# Access Compliance Report

## Public Rights-of-Way

### (Curb Ramps)

Intersection ID: N/A	Main Street: LANGWELL_LN	Cross Street: HAMILTON_BRIDGE_RD	Location: SE
ADA ID: 0D0E3C20A197	Ramp Type: Perp	Initial Pass/Fail: Fail	Overall Compliance: No
Codes/Mitigation Info/Possible Solution		Field Measurements/Component Compliance	
Severity Score: 10

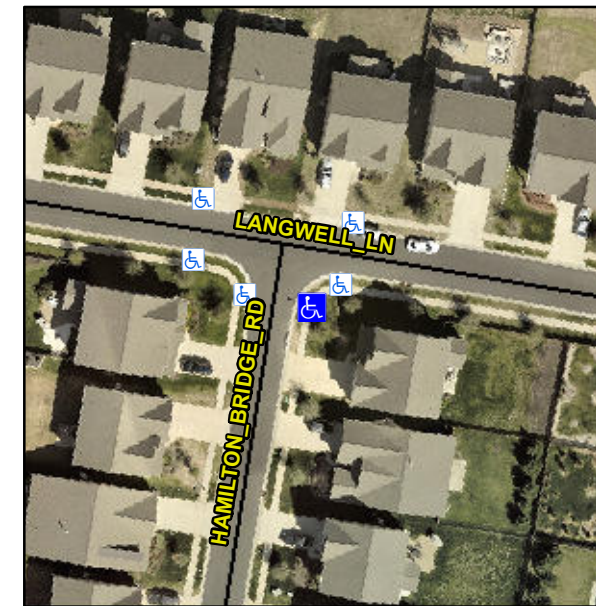
**R304.5.1, R304.5.3**

Compliance	Description	Data	Compliance	Description	Data
N/A	Ramp Length (in)	47.5	Yes	Ramp Slope (%)	5.6
No	Ramp Width (in)	47.5	No	Ramp XSlope (%)	2.6
N/A	Flare Type LT	N/A	N/A	Flare Type RT	N/A
N/A	Flare Slope LT (%)	N/A	N/A	Flare Slope RT (%)	N/A
N/A	Flare Traversable LT?	N/A	N/A	Flare Traversable RT?	N/A
N/A	Landing Length (in)	N/A	N/A	DWS Provided?	N/A
N/A	Landing Width (in)	N/A	N/A	DWS Contrast?	N/A
N/A	Landing Slope (%)	N/A	N/A	DWS Length (in)	N/A
N/A	Landing X Slope (%)	N/A	N/A	DWS Full Width?	N/A
N/A	Landing Curb? (Y/N)	N/A	N/A	DWS Offset (in)	N/A
N/A	Shared Landing?	N/A			
N/A	Gutter Ponding?	N/A	N/A	Gutter Slope (%)	N/A
N/A	Gutter Lip Ht (in)	N/A	N/A	Gutter X Slope (%)	N/A
N/A	Painted X Walk1?	No	N/A	Painted X Walk2?	N/A
	X Walk 1 Direction	To W		X Walk 2 Direction	N/A
N/A	X Walk 1 Width (in)	N/A	N/A	X Walk 2 Width (in)	N/A
	X Walk 1 Slope (%)	0.6		X Walk 2 Slope (%)	N/A
	X Walk 1 X Slope (%)	5.0		X Walk 2 X Slope (%)	N/A

**Remove & Replace Entire Ramp.**
